RECEIPT DATE: 2-1-18 **ONSITE SEWAGE DISPOSAL SYSTEM** P 562419

SUBDIVISION: Five Hills Farm LOT: 3 TAX ID: \_\_\_\_\_

RE: Five Hills Farm, Lot 3  
13900 Old Frederick Rd.  
Sykesville, MD 21784  
*(Septic Plan Comments)*

**SEPTIC PLAN**  
**FIVE HILLS FARM, LOT 3**

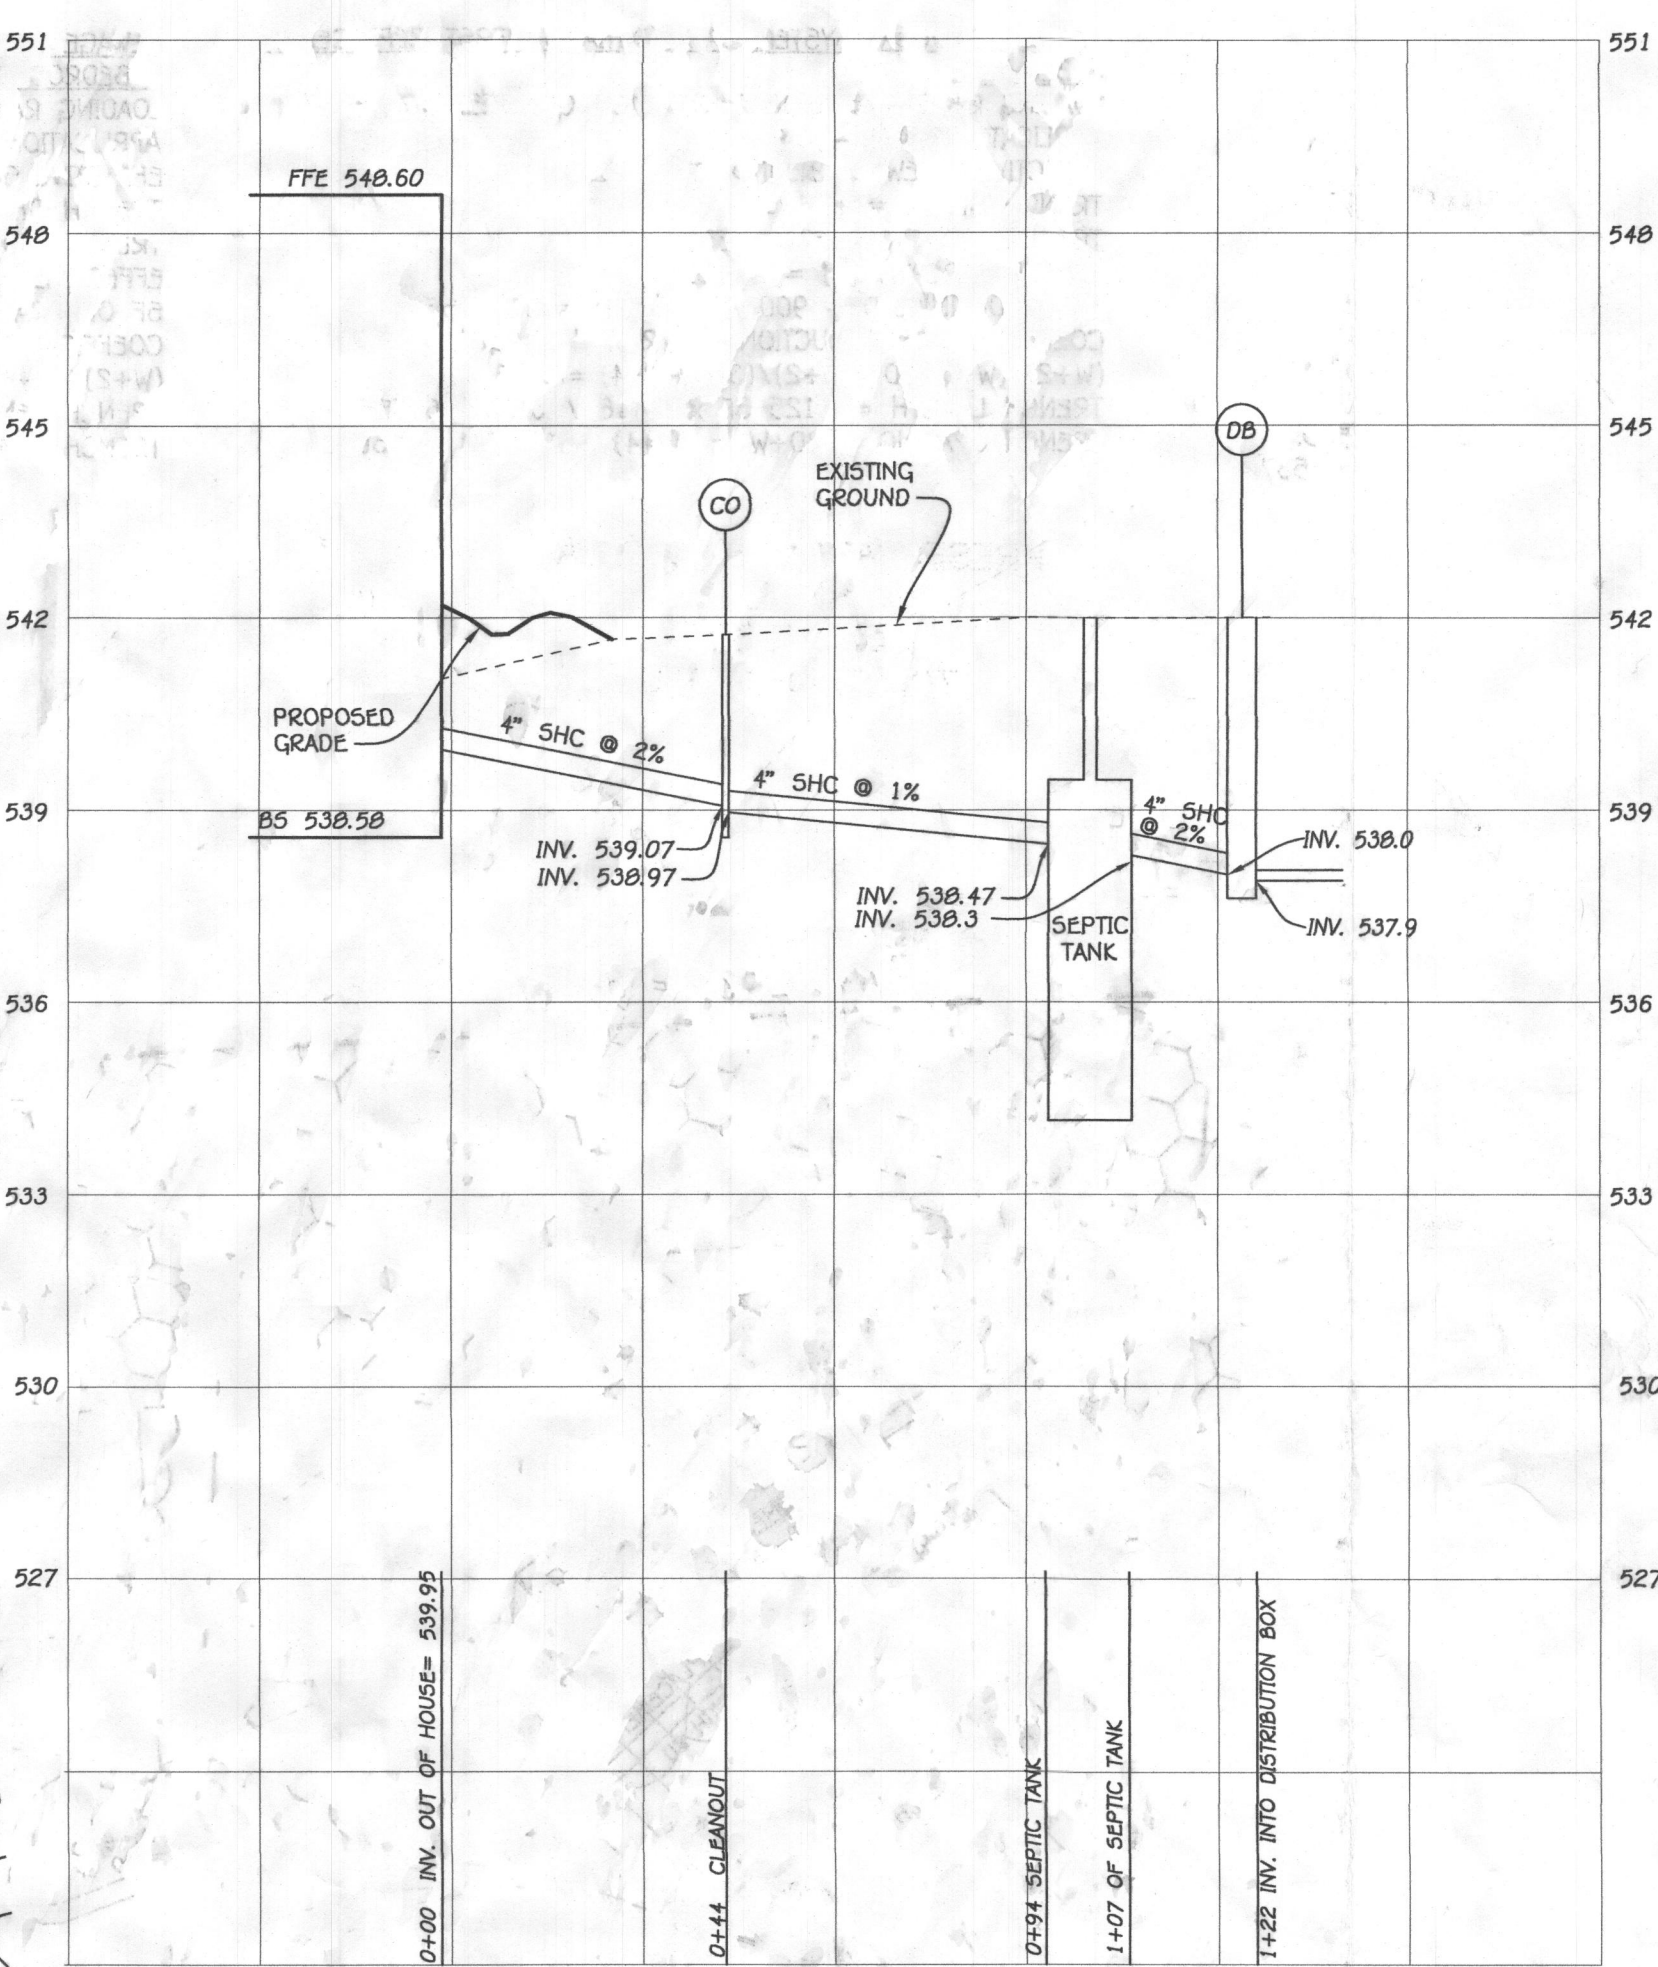
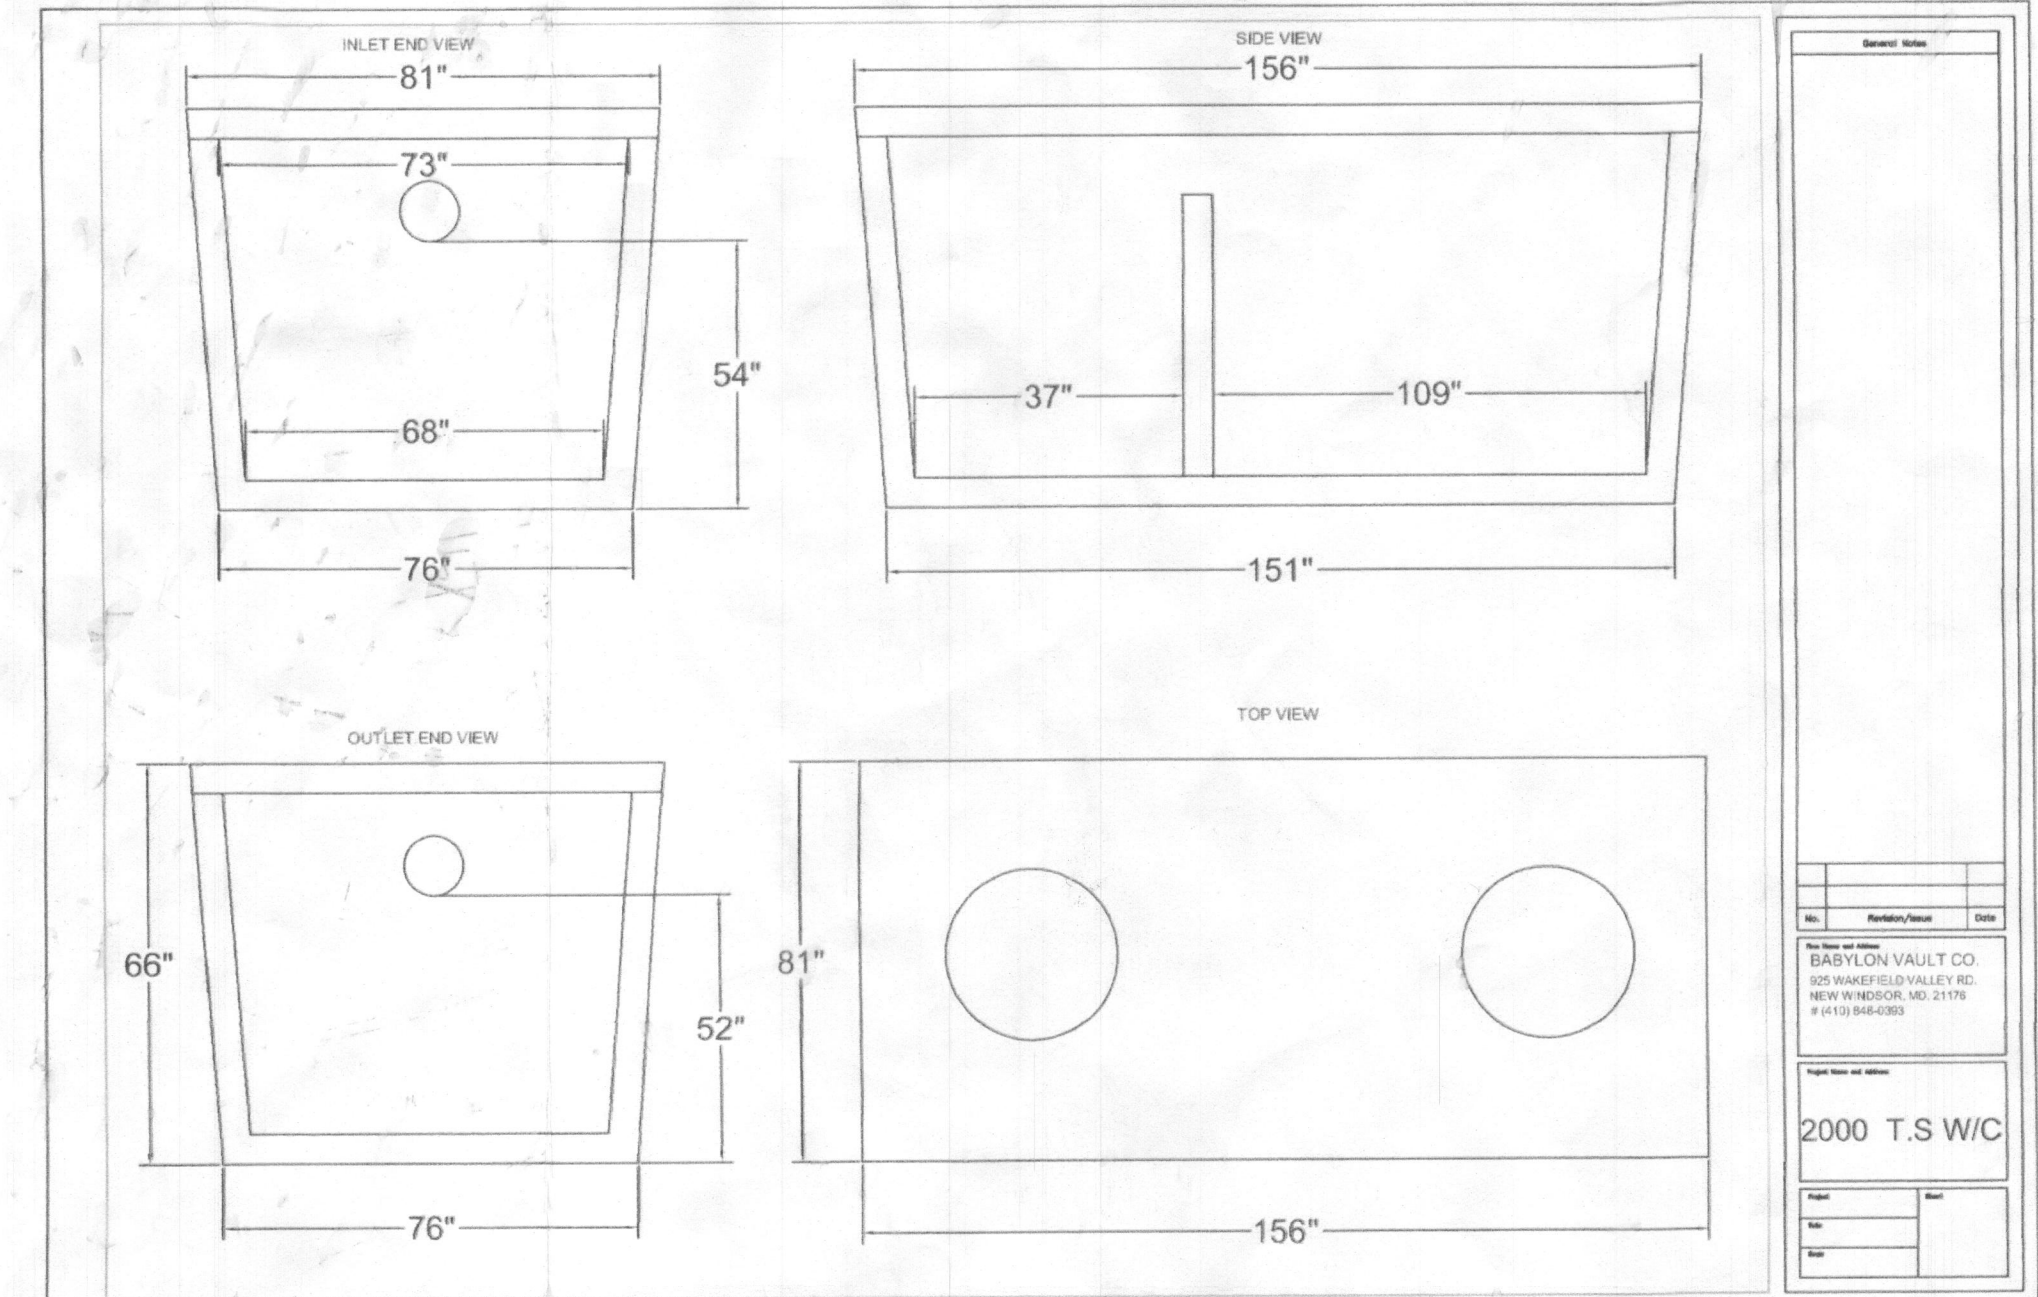
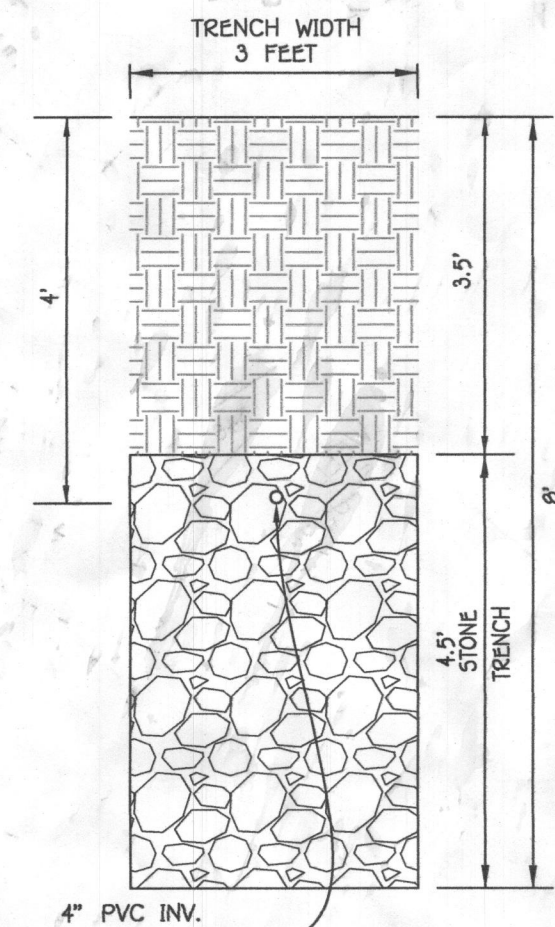
I have reviewed the septic plan and I have two comments. The invert out of the house is written as 537.0 in the list of elevations and written as 538.66 in the profile section. Let me know which one is correct and I can redline it for you. Other than that I noticed the existing grade inside the SDA changed between the new and old plan by about a foot. Are these elevations on the new plan accurate to what is out in the field?

The field conditions at 13900 Old Frederick Road differ from those shown on the septic plan. The septic contractor has installed the sewer line, tank, and distribution box, and with 1% fall in the pipe from the house to the distribution box, the distribution box is currently at 6.5' depth. The initial system requires an inlet at 4.5' or shallower in order to receive sidewall credit starting at 4.5'. It is not possible to reach the 4.5' inlet by gravity shown on the plan with the current field conditions.

There is no extra room to add any length onto the trenches in the initial system as the initial system and two replacements fill the entire sewage disposal area (SDA). The septic plan must be revised to show a septic tank and pump tank located outside the SDA with effluent pumped up to trenches with a 4' inlet.

Should be 537.00. Not sure what happened topo wise, but with discussion with Sarah I started wondering if topo was off, so we did field run again and the elevations were off by about a foot, so yes, they were based on recent field shots. If you could make the change on the profile that would be great. It is shown correctly, just not labeled right on the profile. Thanks very much.
